SECTION 6
WEIGHT AND BALANCE

NO CHANGES EXCEPT:

94-04b

Moment change due to retracting Landing Gear = -32 in.-lbs.
C.G. RANGE AND WEIGHT

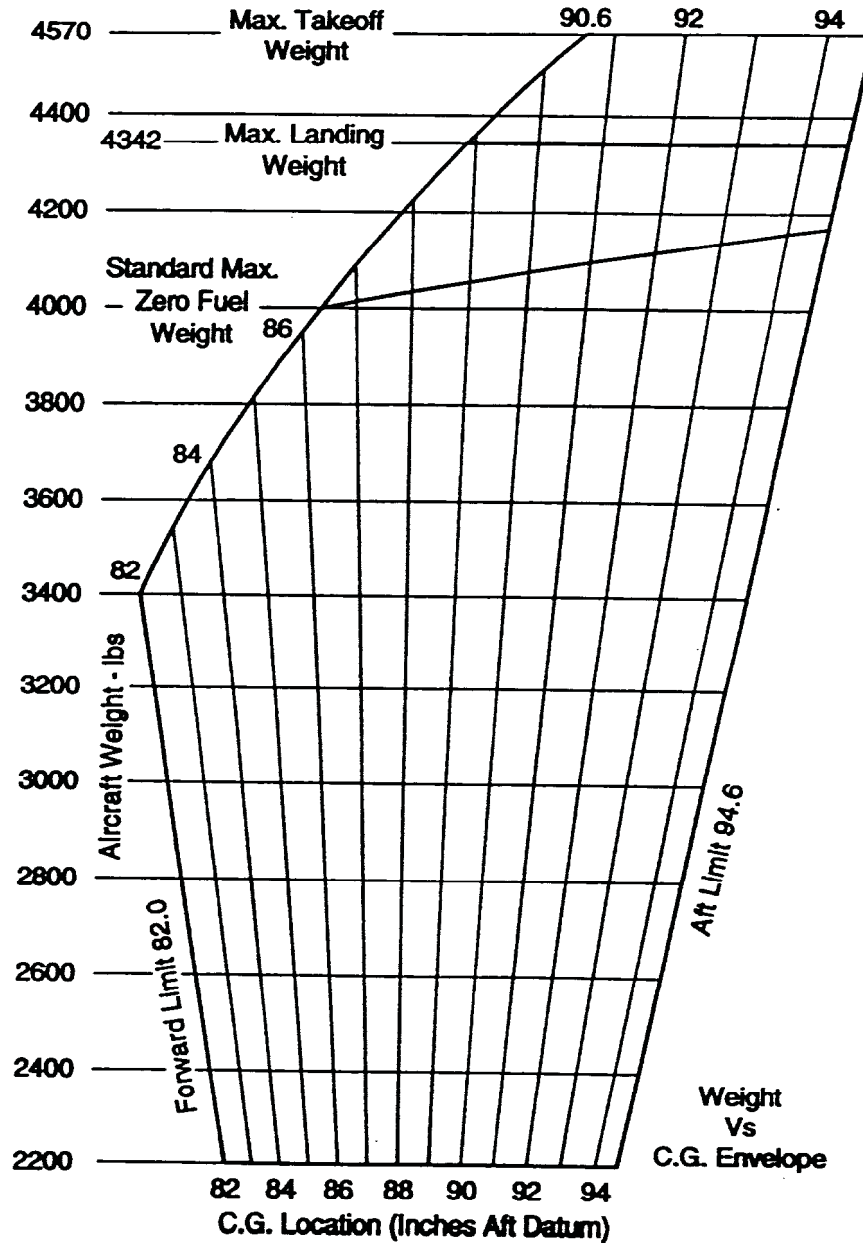
The addition of the ATS, Inc. Vortex Generator Kit increases the Zero Fuel Weight of Seneca II aircraft. Use the following C.G. Envelope Diagram.
